LAKE ROAD CYCLE OPTIONS

Report prepared for
North Shore City Council

ViaStrada Ltd
November 2008

2.1 Option 1: Base Case Cycle Lanes

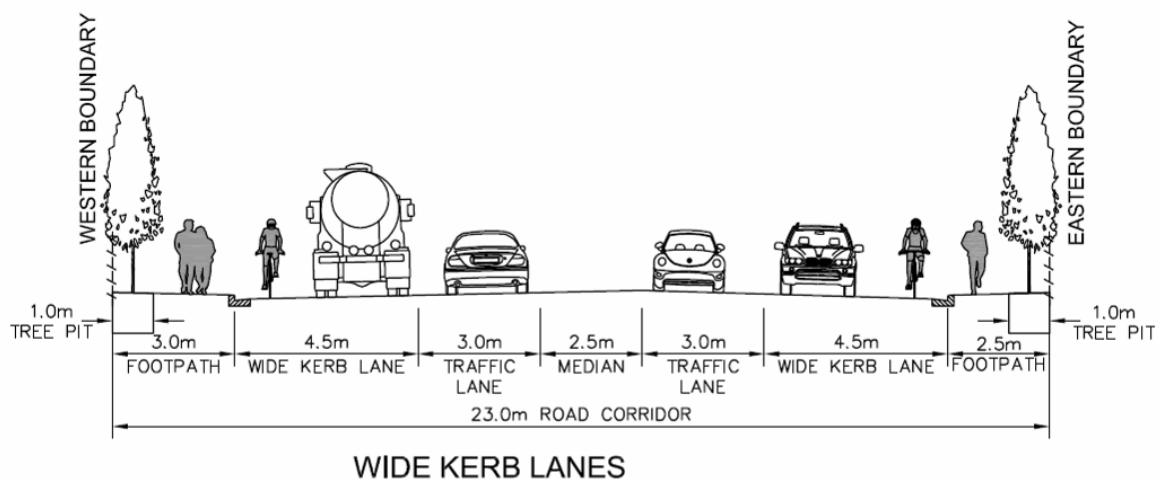
This cross-section provides a 1.5 m wide cycle lane on each side of the road. The New Zealand Supplement to Austroads Guide to Traffic Engineering Practice Part 14 Bicycles (the NZ Supplement) notes that 1.5 m is the “desirable minimum width” for a cycle lane next to the kerb when the speed limit is 50 km/h or less. However, when the 85th percentile speed is “significantly higher” than 50 km/h, then the 85th percentile speed should be used.

With an 85th percentile speed of 60 km/h, then by interpolation from Table 4-1 of the NZ Supplement, the “desirable minimum width” of cycle lanes should be 1.7 m. Lane widths below the “desirable minimum width” (such as the 1.5 m wide cycle lanes in the base case) “should only be used in low speed environments and when it is not possible to achieve greater widths”, according to the NZ Supplement.

The NZ Supplement also notes that “minimum width cycle lanes adjacent to narrow traffic lanes should be avoided”. This provides another reason for rejecting cycle lanes that are 1.5 m wide.

The presence of a sub-standard cycle lane would provide some benefit to cyclists in that it would encourage motorists to position their vehicles in the centre of their lane. This would create more space for cyclists, even though the cycle lane is too narrow. This treatment is not recommended, however.

The “base case” with its 1.5 m wide cycle lanes is thus not recommended.

2.2 Option 2: Wide Kerb Lanes

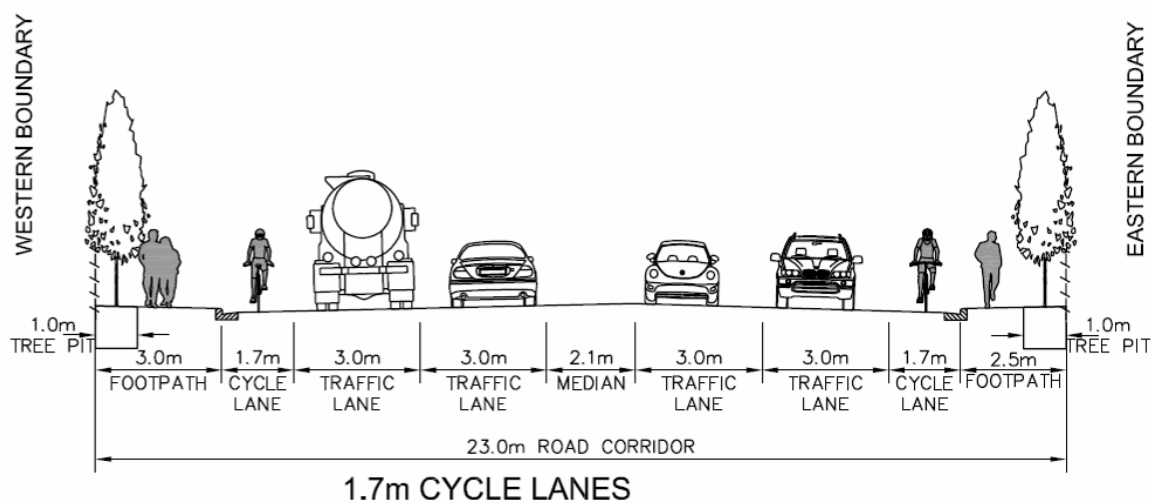
In practice, motor vehicles are likely to travel further from the kerb (thus creating more space for cyclists) if there is a cycle lane marking. Conventional cycle lanes actively promote cycling by identifying to road users that cycling is supported by the road controlling authority and accommodated as part of the transport system.

Motor vehicle traffic speeds are likely to be higher in wide kerb lanes than in narrower lanes, further reducing cyclist safety. If wide kerb lanes are to be established on Lake Road, parking should be prohibited through the use of yellow “no stopping” lines, otherwise some drivers may attempt to park in a lane that feels wide enough to accommodate this.

We do not recommend the use of wide kerb lanes on Lake Road.

2.3 Option 3: Cycle Lanes 1.7 m Wide

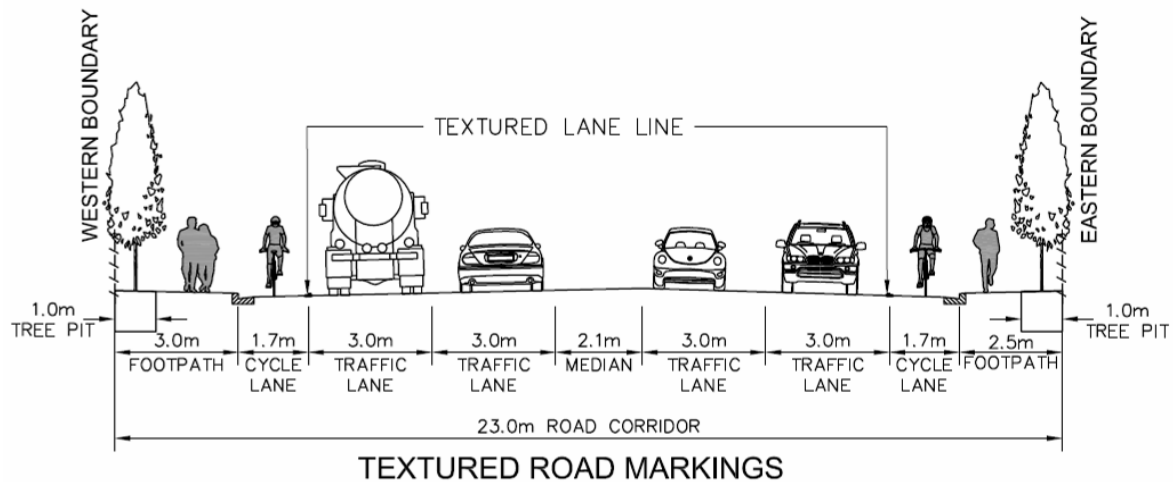
This cross-section provides 1.7 m cycle lanes instead of the 1.5 m lanes of the base case (Option 1). The cycle lane widths satisfy the requirements of the NZ Supplement.

This option can be achieved by reducing the width of the flush median to 2.1 m. This is considered to be acceptable in mid-block locations, but would be too narrow at intersections where a turning bay is required. The median can be retained at 2.5 m by either reducing the width of the four through lanes from 3.0 m to 2.9 m (just at the intersections, where lanes are often narrowed) or by reducing the width of the western footpath from 3.0 m to 2.6 m.

This is a good option in our opinion. A slight improvement on this option is discussed in Option 7.

Figure 3: Motor vehicle encroachment into cycle lane from Lake Rd to Esmonde Rd

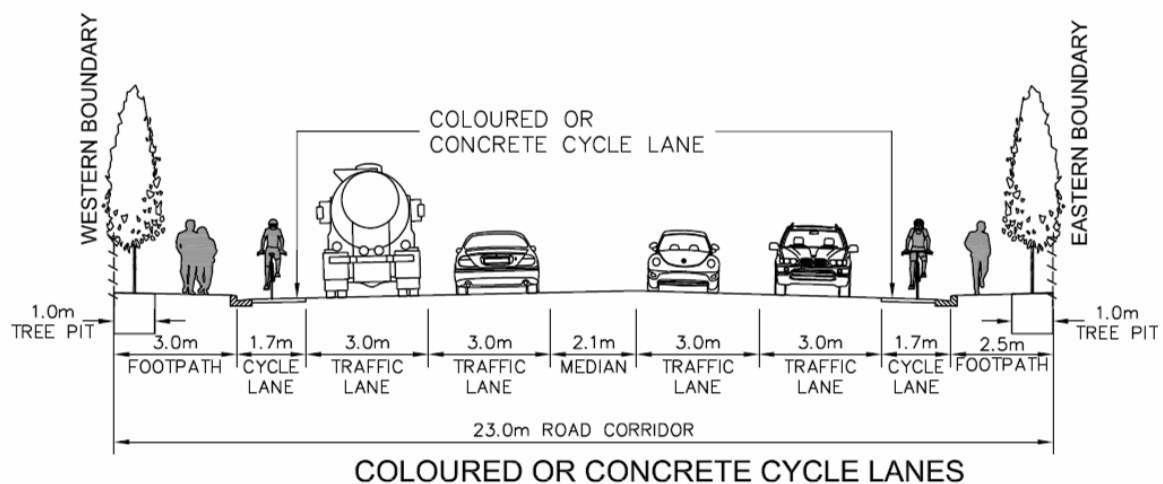
Low (4 mm) textured road markings may be a useful treatment for the insides of curves to support the cycle lanes. The cycle lane from Lake Road (northbound) to Esmonde Rd (westbound) is one location where this treatment is recommended for trial, as motor vehicle encroachment into the cycle lane is common. This location is illustrated in Figure 3.

If textured road markings were used to mark the cycle lane on straight sections of road, we recommend that the cycle lane should be at least 1.7 m wide and preferably 2.0 m wide so that cyclists do not need to cross the line when overtaking other cyclists.

We recommend their use as a trial initially at the Lake Road / Esmonde Road intersection, as illustrated. We do not recommend this as a continuous treatment along Lake Road, however, until the treatment has been tested on the Lake Rd / Esmonde Rd curve.

2.7 Option 7: 2.0 m Uphill Cycle Lane

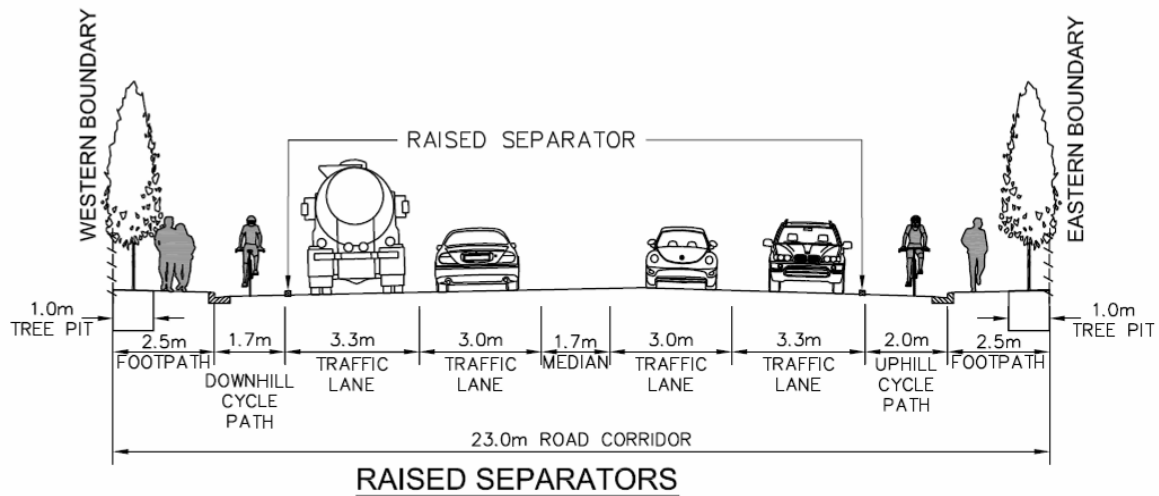
A 2.0 m uphill cycle lane would provide the opportunity for faster cyclists to overtake slower cyclists without leaving the lane, a feature that is likely to be increasingly valued in future as cycle traffic volumes increase. It also would increase the separation between motor vehicles and cyclists, improving the comfort and safety of both drivers and cyclists.

This cross-section requires the narrowing of the west footpath to 2.8 m and median to 2.0 m. The uphill cycle lane could be narrowed to 1.9 m and the four through lanes could be narrowed to 2.9 m at each right turn pocket at the side streets, to allow for a 2.5 m turn lane. The uphill lane should also be reduced to 1.7 m at the Hauraki Rd signalised intersection to discourage car drivers from using the cycle lane as a “queue jump” lane.

This option provides a better level of service for cycling than Option 3 (1.7 m cycle lanes in both directions) and would accommodate the subsequent use of textured lane markings if they prove satisfactory in trials recommended in Option 4.

Accordingly, Option 7 is our preferred option, retaining as much functionality and safety for all road users as possible in this constrained corridor.

Figure 8: Plan of Intersection Island Separators

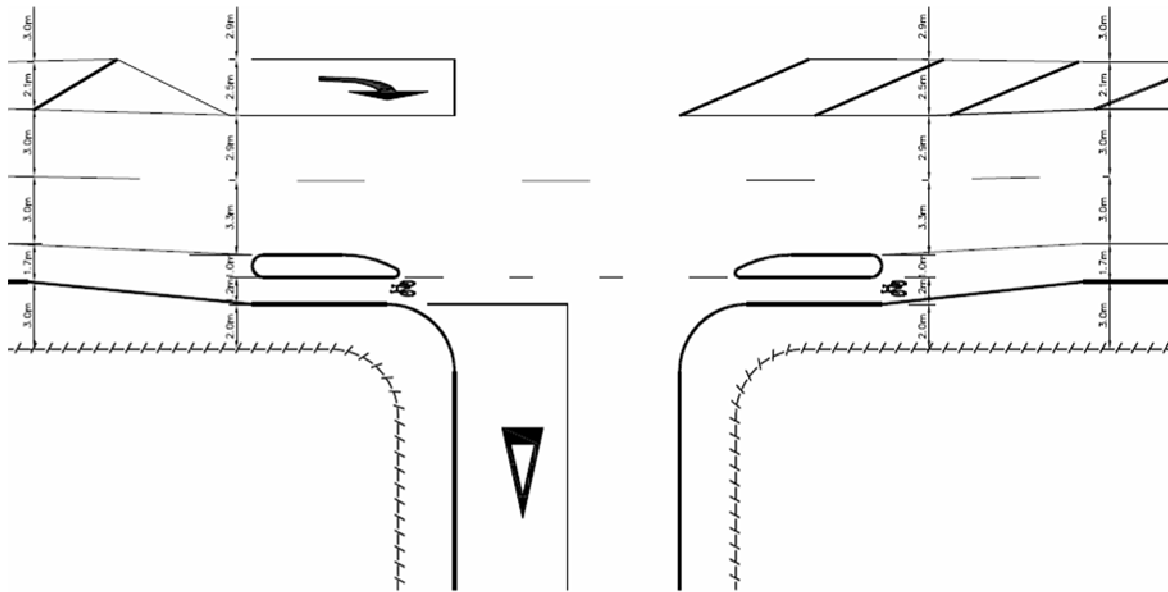
As detailed (Figure 8), the right-of-way of on-road cyclists is unambiguous for drivers on the side road. The island location design will need to accommodate carefully the swept paths of departing left-turning vehicles to avoid forcing those vehicles entering the left-hand through traffic lane into the right lane.

A disadvantage of this option is the difficulty that would be experienced by mechanical street sweepers. The 1.2 m cycle lane between the island and the kerb would be too narrow for mechanical street sweeping so would be likely to accumulate broken glass, gravel and other road debris. Cycles are more susceptible to such surface impediments than motor vehicles.

The island down-stream of the intersection should not be configured in a way that suggests that it is a pedestrian refuge, because this would encourage pedestrians to cross at the right turn lane, an intrinsically unsafe proposition.

There is a risk with this design that the islands will be struck by motor vehicles. This happens frequently with small islands in roadways. If these islands are frequently struck, there are likely to be demands to remove the islands altogether. If this eventuates, the design would revert to similar designs with 1.7 m cycle lanes, but the footpaths will be unnecessarily narrowed at the intersections because of the (former) islands and the cycle lanes or traffic lanes would be undesirably wide at these locations.

We do not recommend this option.
